**Castle Farm, Upton Bishop, Ross-on-Wye,
Herefordshire, HR9 7UW**

Addendum to Flood Risk Assessment and Drainage Strategy

Planning Application 181523

Response to drainage comments made by Balfour Beatty Living Places on
behalf of Herefordshire County Council

Fig 1 Schematic of surface water drainage system with relevant levels and sizes of features

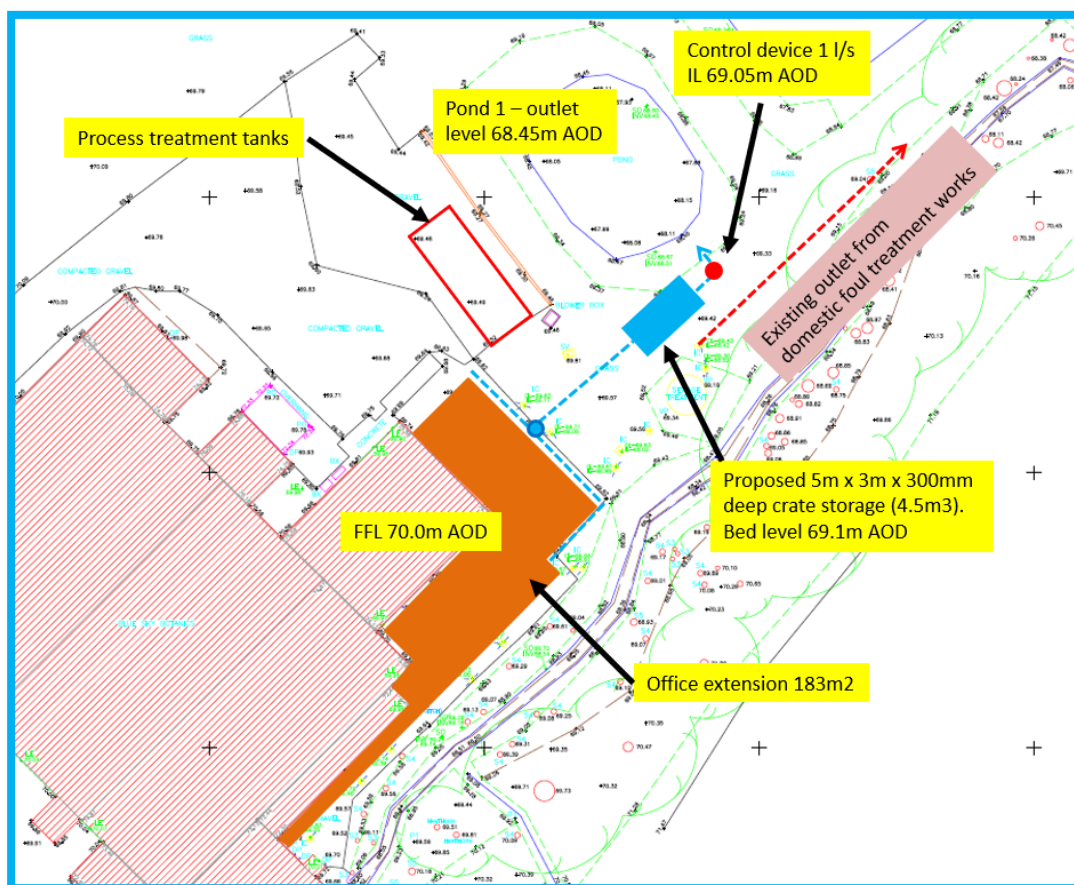
The Council has requested details of the runoff from the proposed extension.

The Applicant should provide further information in regards to the restriction devices used between ponds, beds and the watercourse. The drainage strategy must demonstrate that the ponds hold sufficient capacity to cope with the 1 in 100 year + 40% event. It appears that the ponds are often at full capacity. It may be necessary to raise the banks of the ponds to provide additional storage to ensure that there is no increased risk of flooding to the site or downstream of the site as a result of development between the 1 in 1 year event and up to the 1 in 100 year event and allowing for the potential effects of climate change.

The roof area has been provided by the Architect at 183m².

The 1 in 30 year flow from the 183m² roof is about 3.8 l/s. The capacity of a 100mm drain at a gradient of 1 in 60 is about 7.5 l/s, showing that this pipe size is adequate for draining the roof in normal and extreme events.

It has been decided to control the runoff rate from the roof to the lowest practical level of 1 l/s, using a *JFC Civils* flow control device (approved by water companies) which mobilises attenuation in a conventional crate-type tank.

Calculations have been prepared (see Appendix 2) which show that the attenuation volume required would be 4m³ to manage the 1 in 100 year event with 40% additional climate change allowance.

It is proposed to install a shallow crate system (5m x 3m x 0.3m deep) within the landscaped area to the south of Pond 1 which will be grassed over. The floor level of the building is 70.0m AOD and the outlet from Pond 1 is at 68.45m AOD, thus providing plenty of fall for effective drainage.

The tank will have a base level of 69.1m AOD, and the outlet will fall to discharge into the pond through a proprietary headwall at 69.0m AOD, 550mm above the outlet pipe from the pond.

The above description shows that the rate of runoff from the roof will be attenuated to the minimum controllable flow, with adequate falls etc, which can manage flows safely up to and beyond the 1 in 100 year event with climate change allowance. The interception of silt and maintenance is described in the FRADS.

Fig 2 Fig 16 from FRADS showing route of domestic waste effluent in red broken line passing Ponds 1 and 2 in a pipe and then passing through the Reed Bed and Willow Bed before any residual flow is discharged into the watercourse.

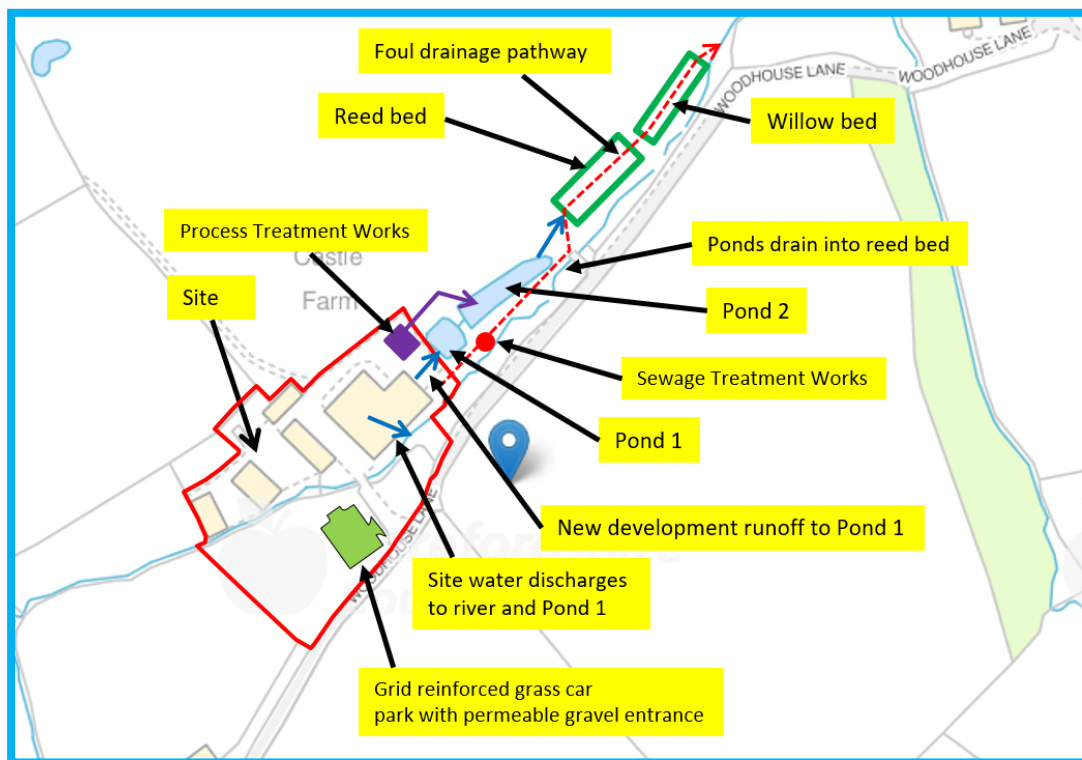
Section 7. of the FRA states that the effluent from the package treatment plant is directed to the reed bed and then to the willow bed (this should be clarified). This is not reflected in the drawing on page 14 as it is shown to enter pond 2 prior to the reed bed. This should be clarified.

Domestic effluent from the kitchen and toilet facilities in the offices is drained by gravity to a package treatment works.

The treated effluent is then drained by gravity to the Reed Bed, then to the Willow Bed, and if there remains any flow which is not dispersed by evaporation and evapotranspiration the residual clean water runs into the watercourse.
